STAFF REPORT: 10/08/2025 MEETING

ADDRESS: 264 WATSON

APPLICATION NO: HDC2025-00592

SCOPE: ERECT PORCH AT FRONT AND SIDE

264 Watson, current conditions. Showing non-historic front porch (red arrow) and historic east side porch (yellow arrow). Photo by staff taken 9/22/2025

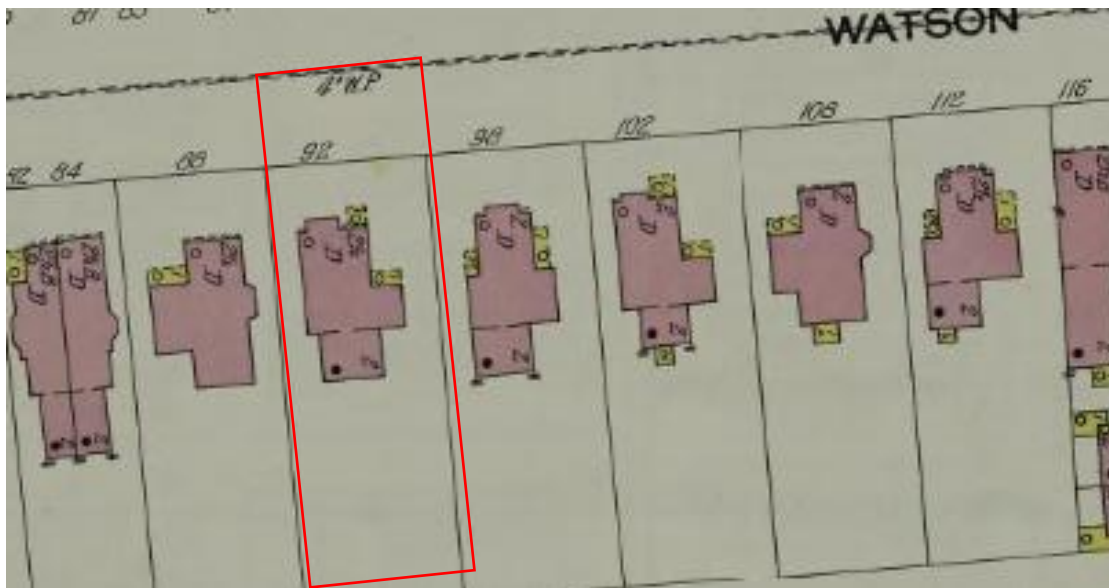
- Google Streetview images indicate that the later, non-historic front porch which was added in 1981 was removed sometime between 2011 and 2013 without HDC approval, leaving the masonry steps. The current front porch columns, roof, and railings were installed in 2021 without HDC approval (see below). Staff supports the proposed removal of the current front porch as it is not of historic age and does not contribute to the property's historic character.

Rehab drawings from 1981, showing the proposed design of the new porch, which takes cues from the historic east side porch.

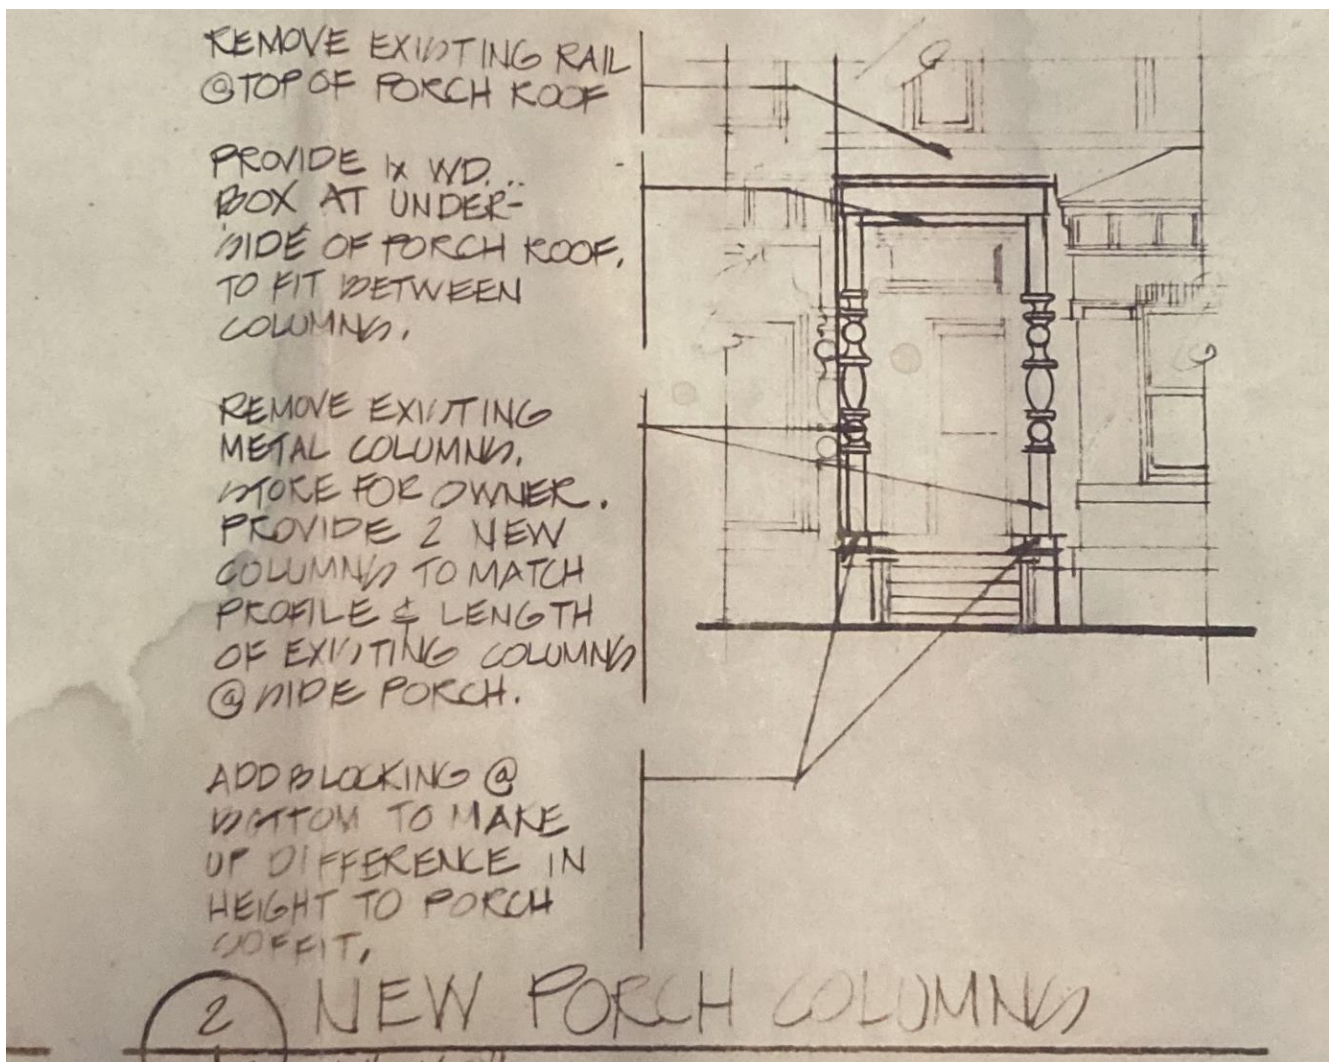
Rehab drawings from 1981 showing the front (yellow arrow) and side porch (red arrow) conditions at that time. The project proposes to replace the non-historic front porch with a new porch which takes design cues from the historic east side porch. Note that the side porch was not proposed for repair, likely because it was in good condition and retained elements that were consistent with the building's historic character.

East side porch, current appearance. Note that the east side porch's decorative details match those at the front façade's bay window. Specifically, the brackets at the porch soffit/eave area match those at the front facade bay (outlined in yellow). Provided by applicant

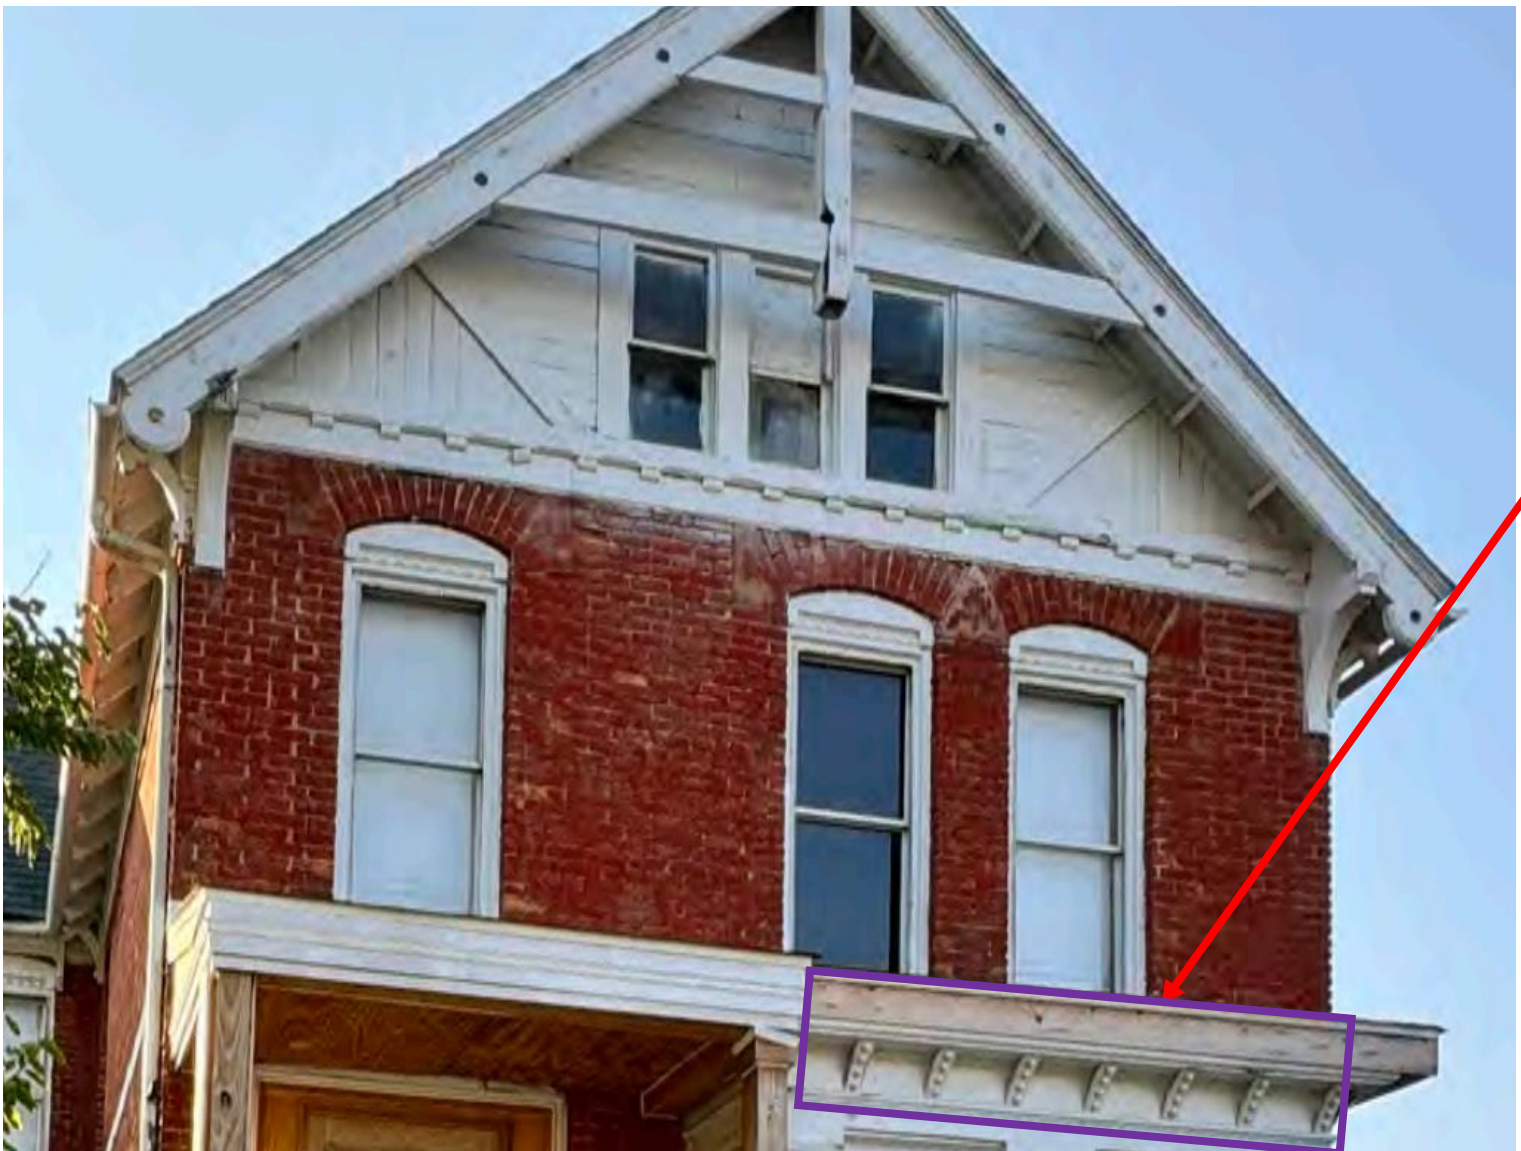
- With respect to the historic east side porch, staff notes that it currently appears much as it did at the time of local designation/when the building was identified as Contributing to the historic district. It is staff's opinion that the side porch is a distinctive character-defining feature of the building as it displays historic-age details which are associated with the Queen Anne style and are reflective of decorative detailing elsewhere on the building. A review of Sanborn maps (provided above) indicates that the porch has been extant since 1887. Also, note that the Commission determined that the east side porch was a distinctive, character-defining feature of the property at their 12/11/2025 regular meeting. The Commission upheld this position at their 02/12/2025 meeting. The porch also appears to remain in relatively good condition and therefore should be kept and, where deteriorated, repaired using in-kind materials. The below indicates the the areas/elements of the porch that are in poor condition and the elements that do not date from the building's original construction as noted by the applicant.
